# Pheasant Run Condominiums

Ledyard, Connecticut

Environmental Review Team  
Report

April 1983

CONCEPTUAL DESIGN  
for  
PHEASANT RUN SWIRLCLUB CONDOMINIUMS

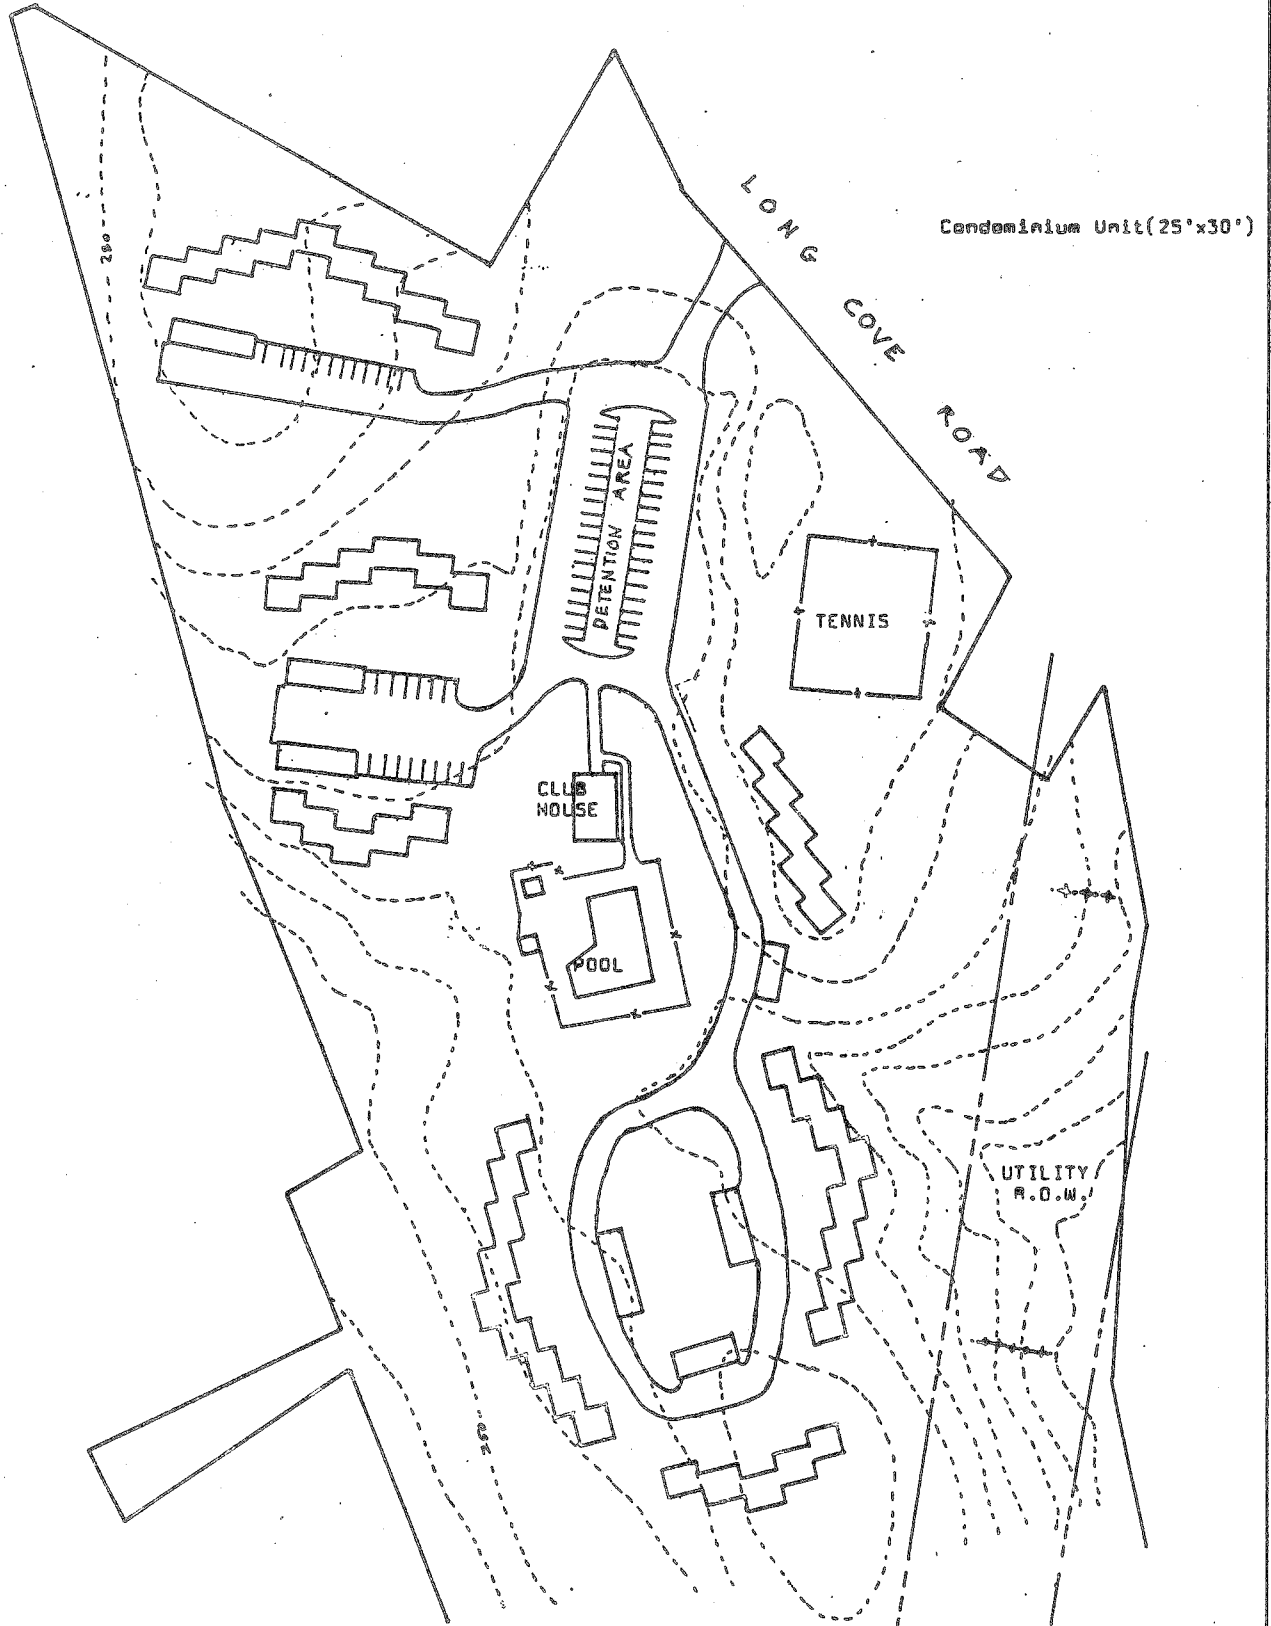
It is important that this project be compatible with its neighbors. As previously described, those neighbors are almost entirely single-family detached houses. The majority of these houses are located on relatively small lots; that is, lots less than one acre in size. In order to be compatible with these, the condominium complex must not present the appearance of a large institution. It is still a residential project, and it should have a residential scale.

The buffer strips required by the Zoning Regulations have been mentioned above. These are important, but they should not be expected to solve the problem of neighborhood compatibility by themselves. They could have the effect of isolating the large project from the neighborhood. This would be especially true if the buildings containing the condominiums were large in scale and institutional in appearance. Then the "image" of the project for the neighbors would be as an enclave in which people lived who were insulated from the community. However, if the buildings containing the condominiums are designed to be small in scale and have a residential character, the differences between the project and the neighborhood will be minimized. One way to achieve a residential character would be to have the buildings emphasize the individual units through changes in rooflines and breaks in the walls. A barracks-like aspect could thereby be avoided. Also, there should not be too many units in a building. The Zoning Regulations permit a maximum of eight units. However, a building containing eight units each twenty-four feet wide will be 192 feet long, hardly residential in character.

On the preliminary site plan, garages are shown located adjacent to the apartment buildings. We were told that these will contain space for one car per unit. However, no other parking is shown with the exception of the entrance lot near the swimming pool and recreation area. The Zoning Regulations require two spaces per unit. It is important that the extra parking, which need not have a roof over it, be located as near as possible to the units it serves. Not only will this provide maximum convenience for the residents, but if the parking area is broken up into small lots, its appearance will be improved.
